### Amendments to the Drawings

### **Remarks/Arguments**

FIG. 2

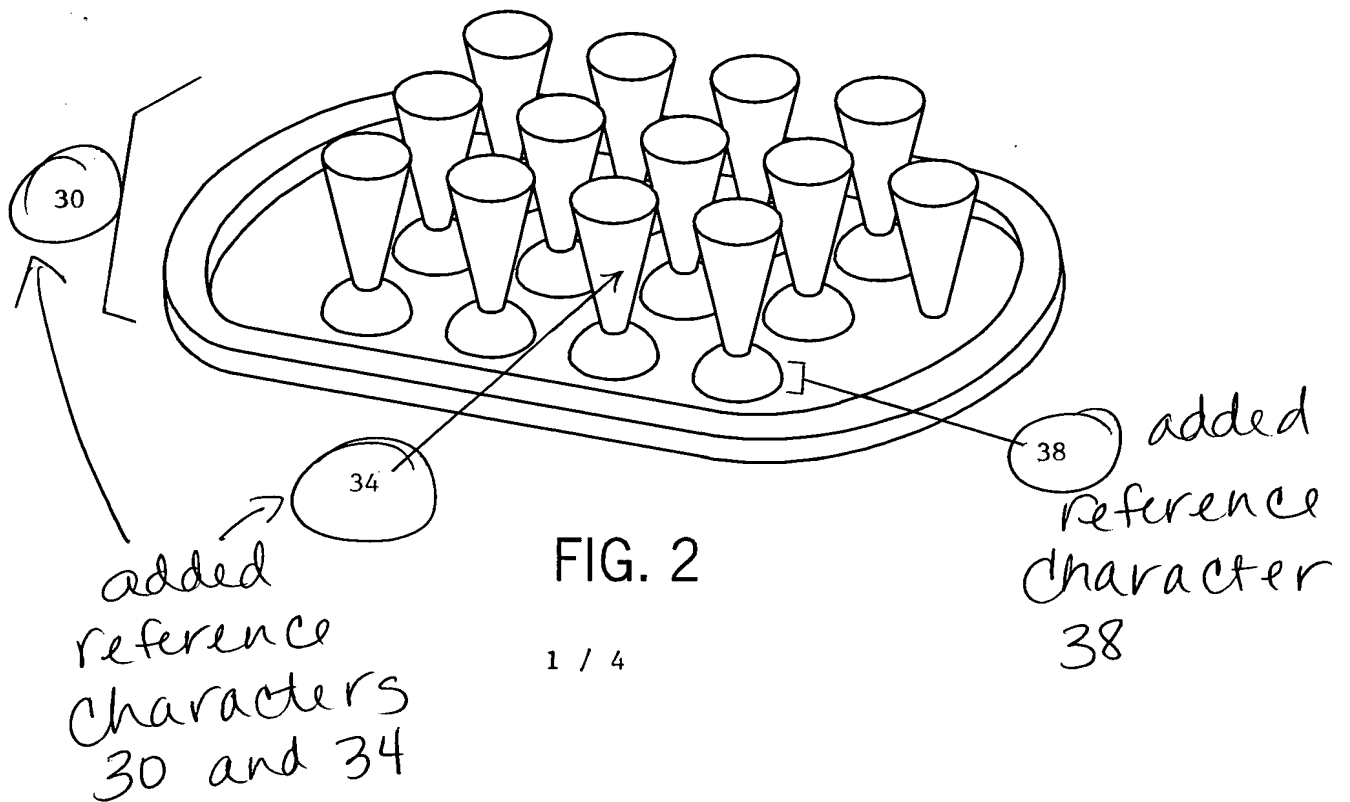
Please replace the existing Figures 2 through 5 with the attached replacement sheets and an annotated sheet showing changes to Figures 2 through 5. In Figure 2 previously omitted reference characters 30, 34 and 38 have been added. In Figure 3 previously omitted reference terms directed towards the sample loading array, channel, subarray and microarray have been added. In Figure 4 previously omitted reference characters 10, 15, 18, 19, 40, 42 and 44 have been added. In Figure 5 previously omitted reference character 50 have been added.

The Examiner also asserts that Figures 2 through 5 do not include the reference characters mentioned in the specification. In response, applicants have amended Figures 2 through 5 of the drawings to comply with 37 CFR §1.84. Specifically, applicants submit herewith replacement sheets and corresponding annotated sheets for Figures 2 through 5, showing that the reference characters have been included.
